**Environmental
Protection Agency**

RE: COLUMBIANA COUNTY
FAIRFIELD TOWNSHIP
CRESTVIEW PERFORMING ARTS CENTER
CONSTRUCTION STORM WATER

On August 3, 2011, I performed a follow-up inspection at the above-referenced site to determine compliance with the Ohio EPA General Storm Water National Pollutant Discharge Elimination System (NPDES) Permit for Construction Activities #3GC04910*AG. Our records indicate that Crestview Local School District was granted coverage under the NPDES permit on May 5, 2010. Our records further indicate that C. Tucker Cope and Associates submitted a Co-Permittee Notice of Intent on November 4, 2010.

Figure 1 – Sediment is being tracked onto the pavement.

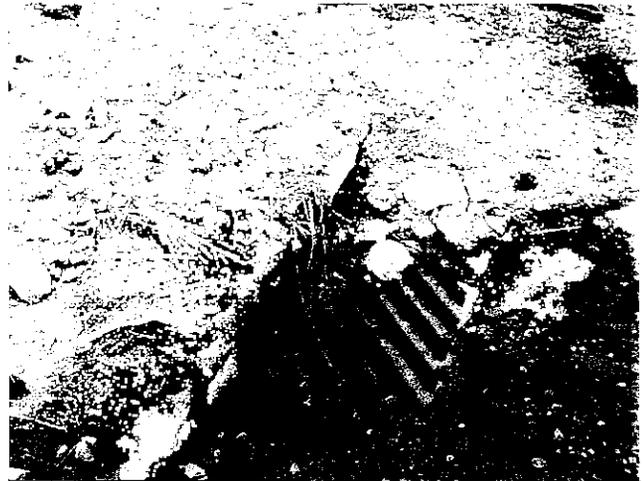
1. The rock construction entrance depicted on the Storm Water Pollution Prevention Plan (SWP3) still has not been installed (Figure 1). Please install this sediment control per the detail in the SWP3 in order to prevent off-site tracking of sediment. In addition, you should regularly sweep the street and the parking lot to prevent sediment from collecting on the pavement and washing into the storm drains.

Figure 4 – Construction debris is present throughout the site.

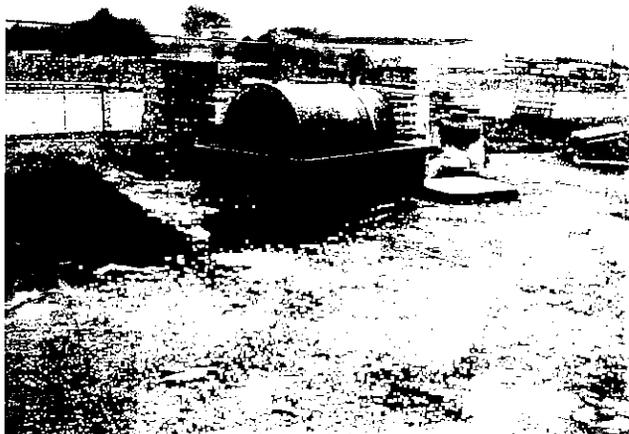
4. Construction debris should be placed in a covered dumpster. Please clean up all waste materials from construction activities and dispose of them properly (Figures 4 and 5).
